Town of Duanesburg Planning Board Minutes October 20<sup>th</sup>, 2022 **Final Copy**  TOWN OF DUANESBURG

Re: Request inspection of tree plantings at Oak Hill Solar 1, LLC and Oak Hill Solar 2, LLC for compliance with arch 23, 2022 site plan

Re: Ultimate Wishy Wash (Spiro Kagas)
Site Plan Application - Car Wash Addition
Our Project No. GNY02WD-22492

March 23, 2022 Site Plan Drawing C5.02 Sheet 21 of 30

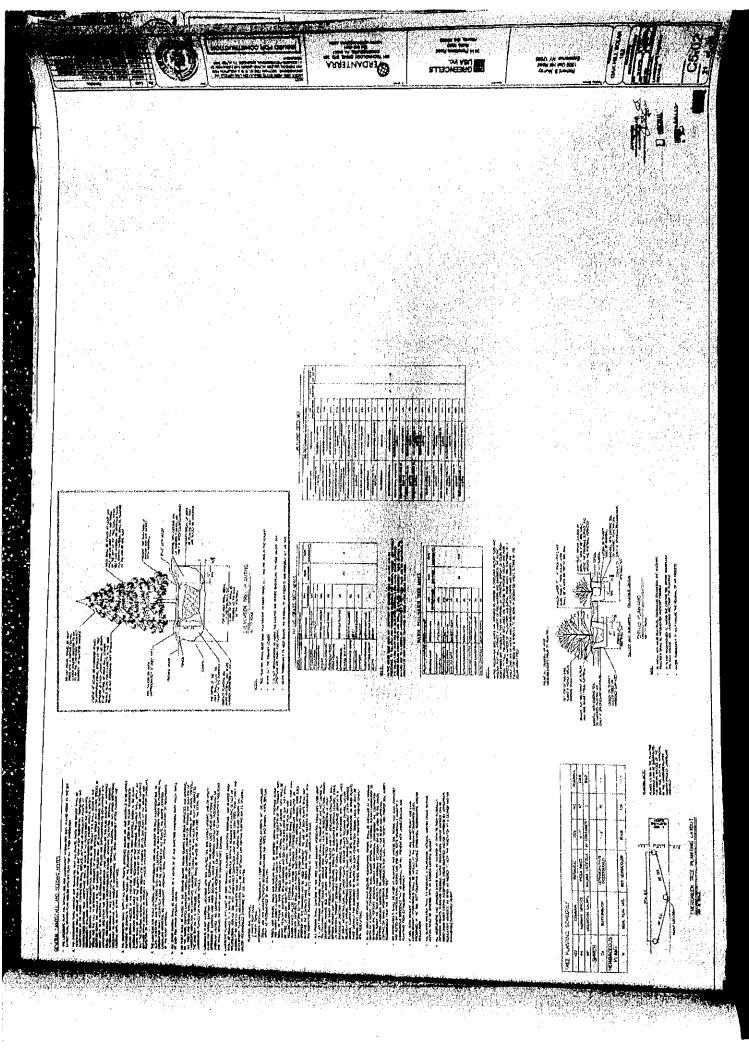
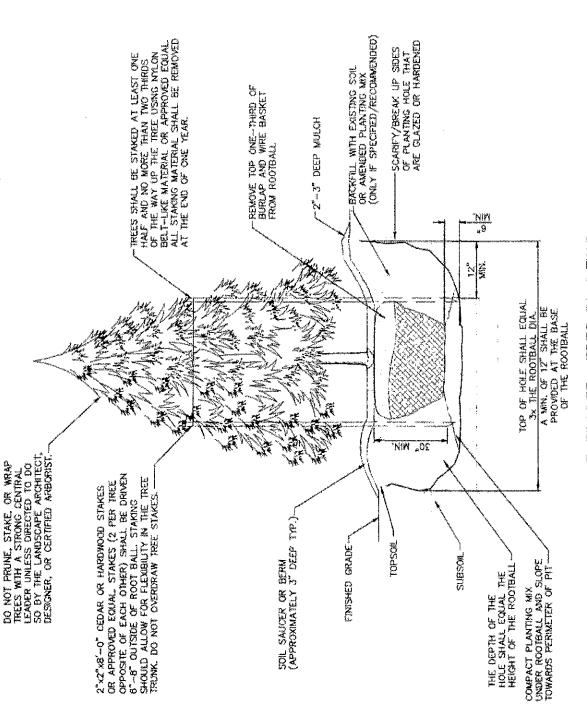
We request the board to direct the town & planning board attorney to require the code enforcement officer to inspect the evergreen tree plantings on the eastern side of Oak Hill Solar 1, LLC and Oak Hill Solar 2, LLC (the "Project") for compliance with the March 23, 2022 Site Plan Drawing C5.02 Sheet 21 of 30 details for tree planting.

Please see attached color image of a typical tree planting found on the east side of the stone wall between the Project and the Biggs parcel 74.00-3-18, and Drawing C5.02 and the detail of tree planting which are attached for your convenience.

The March 23, 2022 site plan requires a hole 3 times the width of the root ball. The holes were drilled. All holes are approximately 36 inches in width. A typical rootball is 28 inches in width. Three times 28 equals 84 inches. The holes are approximately 48 inches deficient. The hole is 60% too narrow. This is a significant deficiency. This appears to be non-compliant.

The site plan requires the top one-third of the burlap and the wire cage around the root ball to be removed prior to planting. Visual inspection indicates that all of the evergreen trees were planted with the all of the burlap intact and the wire cage on the root ball. This appears to be non-compliant.

Please protect the taxpayers and direct the town & planning board attorney to require the code enforcement officer to inspect the evergreen tree plantings for compliance. If the plantings are non-compliant please direct the Project to replant the trees according to the site plan.
